OSSF Inspection Sheet

To whom it may concern: Re: Bedstone project
18735 IH 35 N
Schertz , Tx

Permit of Authorization to Construct an On-Site Sewage Facility Permit Valid For One Year From Date Issued

18735 IH 35 N
SCHERTZ, TX 78154

REVISED SHEET 1.0 - OVERALL SITE PLAN

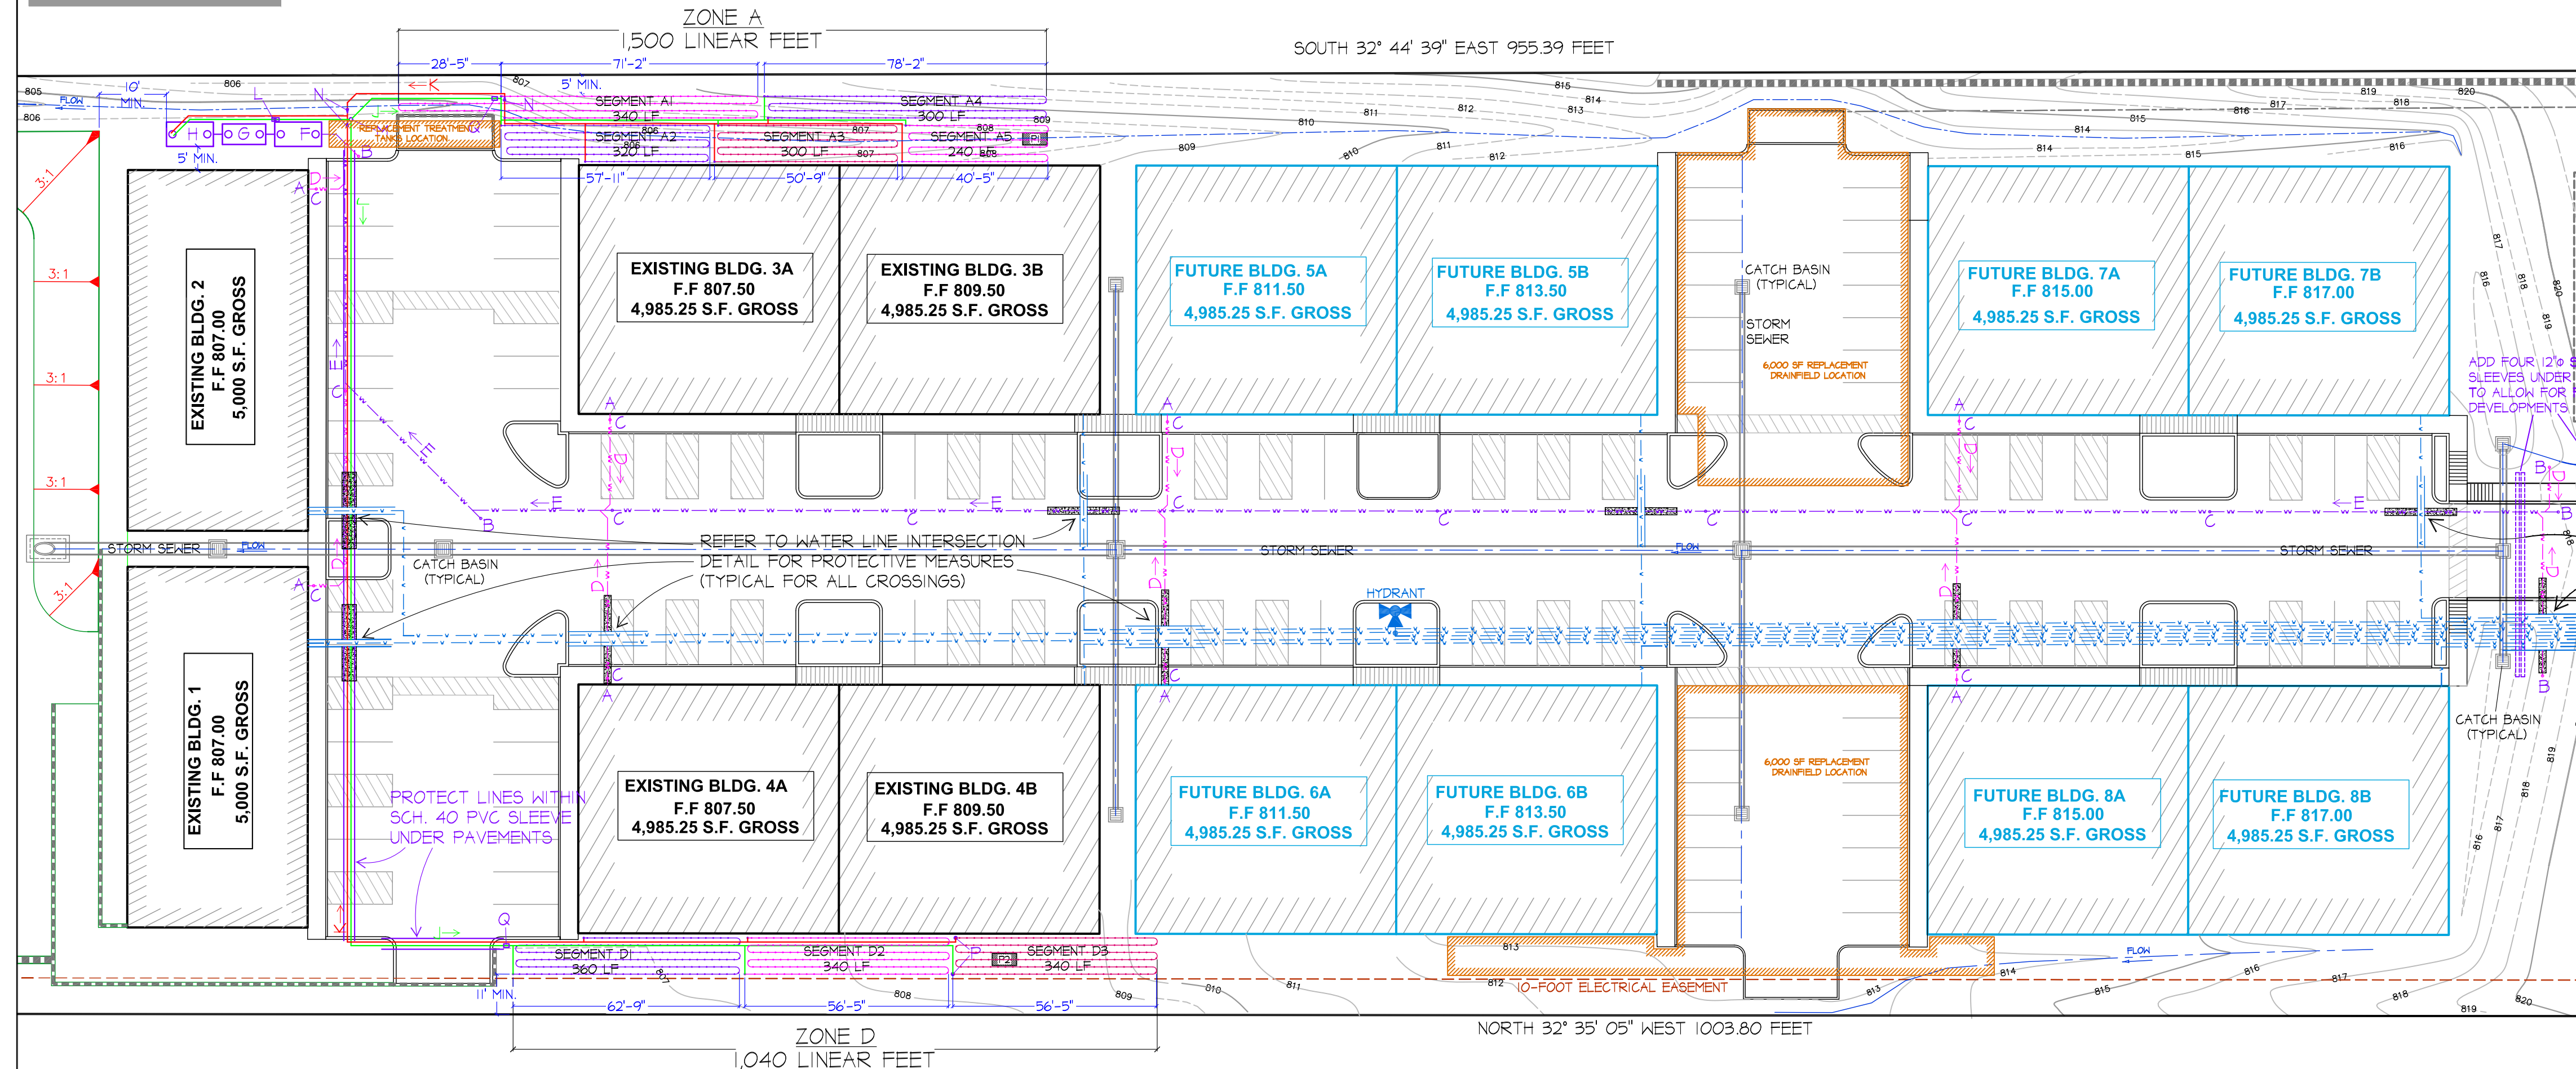
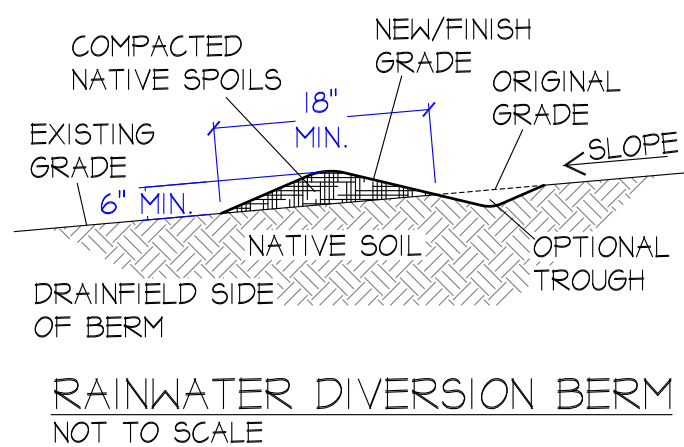
3. The future developments planned for this property have been removed from the updated site plan as instructed.
4. Dimensions for the emitter tubing lengths have been added to the updated site plan as requested.

6. I added the minimum five-foot dimensions from the property line to the septic components. This requirement is also stipulated in the *Setback Requirements* table. Additionally, I added an eleven-foot minimum dimension to the south property line in order to provide the required one-foot setback to the easement.

7. Replacement areas for both the treatment train and a full-size drainfield have been designated on the updated site plan included with this response.

REVISED SHEET 2.0 - TANKS SECTION DETAIL

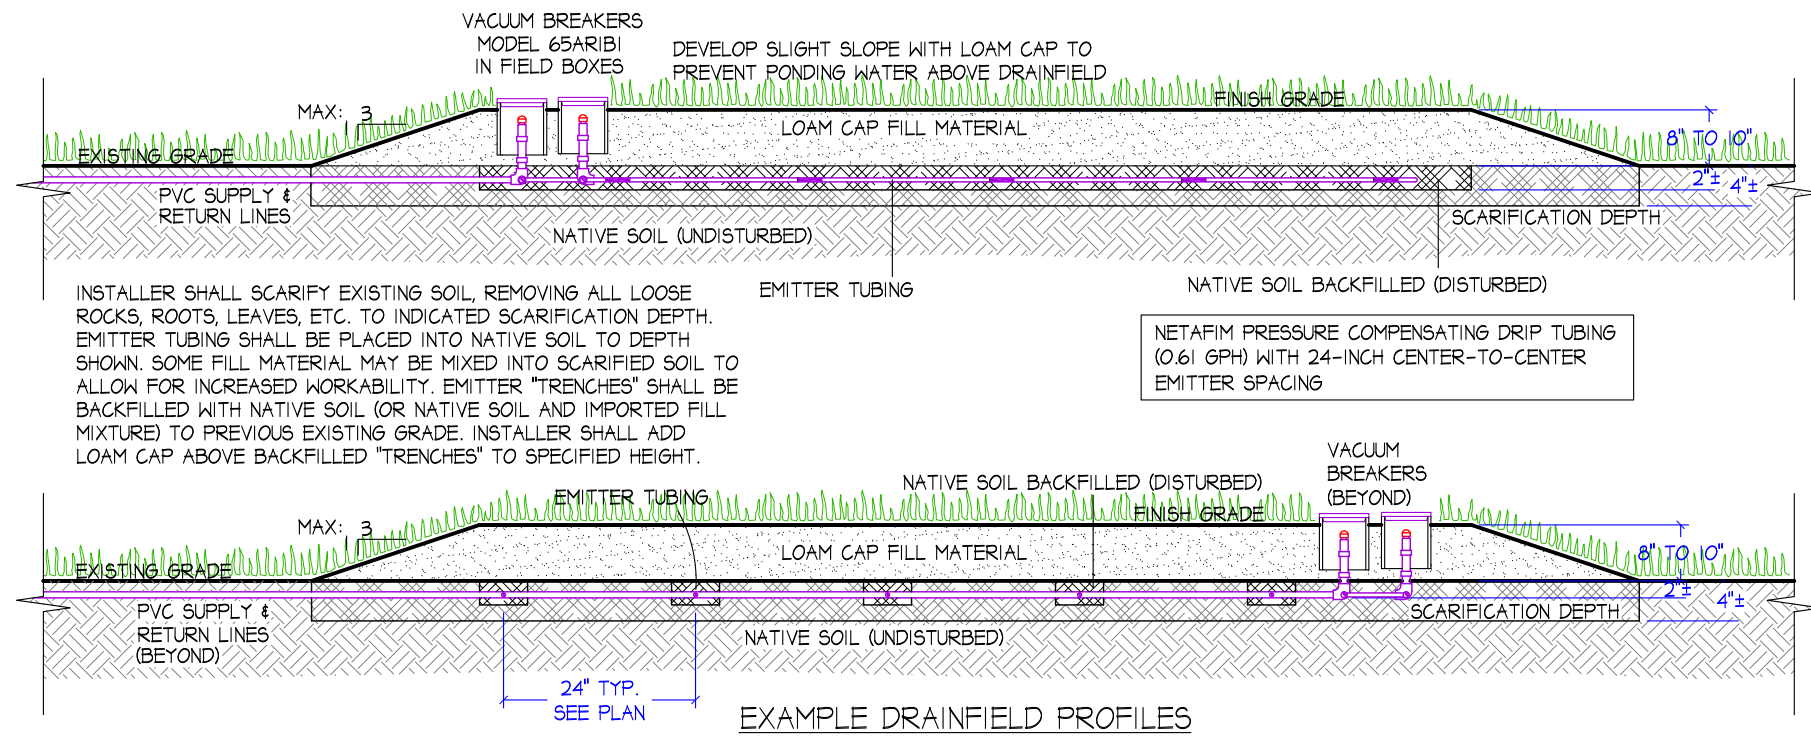
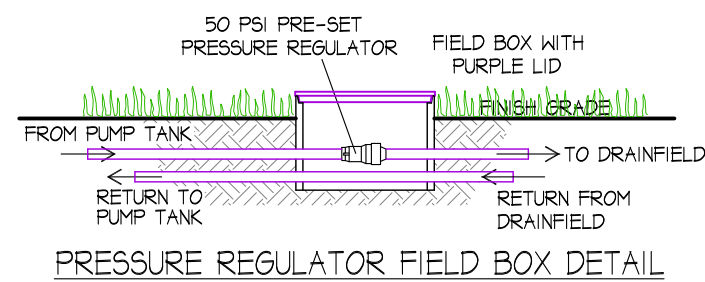
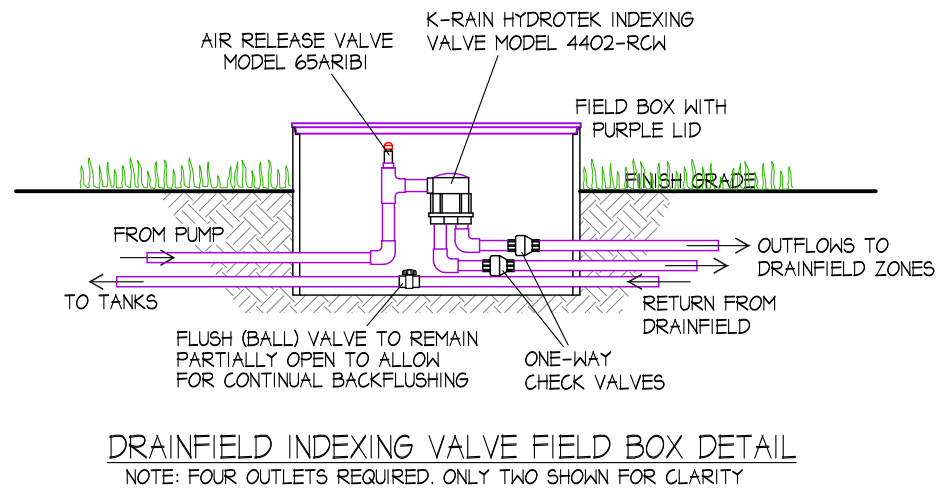
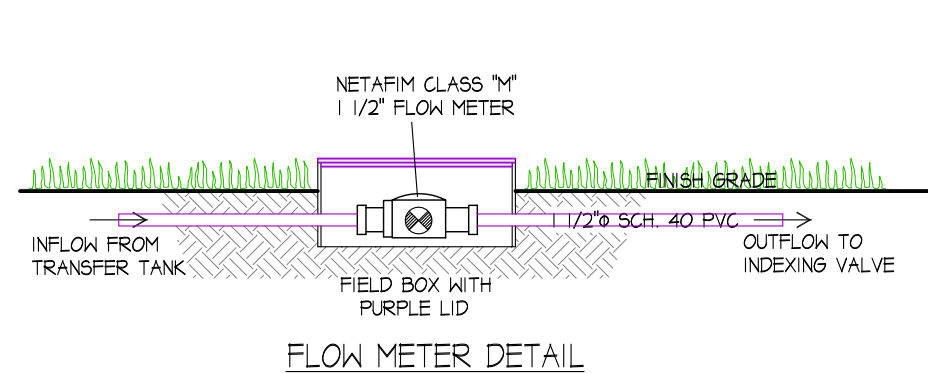
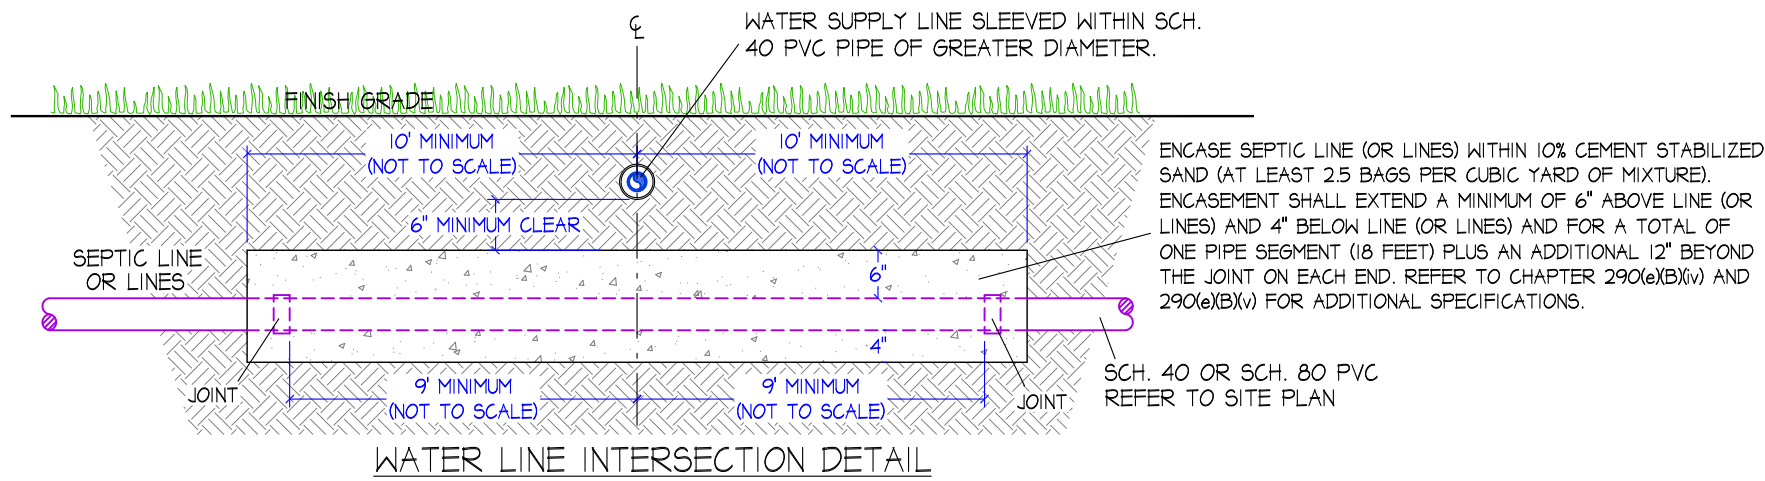
Please also note the treatment train was installed at a deeper depth than previously anticipated. This was necessary to achieve the required fall through the sewer collection lines. The updated tank cross-section detail page specifies the use of Styrofoam blocks above the tanks to reduce the overall volume and subsequent weight of the backfilled soil.
